Access Compliance Report

Public Rights-of-Way

(Curb Ramps)

Intersection ID: 26040	Main Street: NORTH_COURSE_DR	Cross Street: ROUNDING_RUN_RD	Location: SW
ADA ID: FEE52573E569	Ramp Type: PerpDiag	Initial Pass/Fail: Fail	Overall Compliance: No
Severity Score: 10			
Codes/Mitigation Info/Possible Solution		Field Measurements/Component Compliance

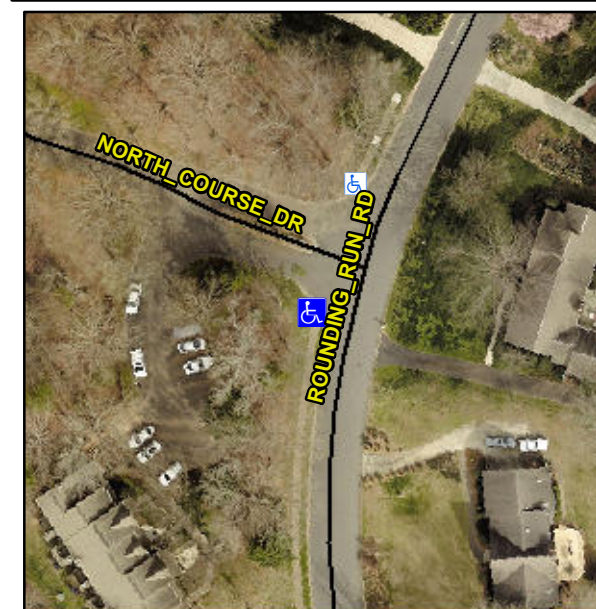
R304.5.1, R304.5.3

Compliance	Description	Data	Compliance	Description	Data
N/A	Ramp Length (in)	48.0	Yes	Ramp Slope (%)	6.5
No	Ramp Width (in)	38.0	No	Ramp XSlope (%)	4.4
N/A	Flare Type LT	N/A	N/A	Flare Type RT	N/A
N/A	Flare Slope LT (%)	N/A	N/A	Flare Slope RT (%)	N/A
N/A	Flare Traversable LT?	N/A	N/A	Flare Traversable RT?	N/A
N/A	Landing Length (in)	N/A	N/A	DWS Provided?	N/A
N/A	Landing Width (in)	N/A	N/A	DWS Contrast?	N/A
N/A	Landing Slope (%)	N/A	N/A	DWS Length (in)	N/A
N/A	Landing X Slope (%)	N/A	N/A	DWS Full Width?	N/A
N/A	Landing Curb? (Y/N)	N/A	N/A	DWS Offset (in)	N/A
N/A	Shared Landing?	N/A			
N/A	Gutter Ponding?	N/A	N/A	Gutter Slope (%)	N/A
N/A	Gutter Lip Ht (in)	N/A	N/A	Gutter X Slope (%)	N/A
N/A	Painted X Walk1?	No	N/A	Painted X Walk2?	No
	X Walk 1 Direction	To E		X Walk 2 Direction	To NE
N/A	X Walk 1 Width (in)	N/A	N/A	X Walk 2 Width (in)	N/A
	X Walk 1 Slope (%)	3.1		X Walk 2 Slope (%)	2.7
	X Walk 1 X Slope (%)	5.5		X Walk 2 X Slope (%)	0.4

Remove & Replace Curb Ramp With Two New Directional Ramps or Equivalent.
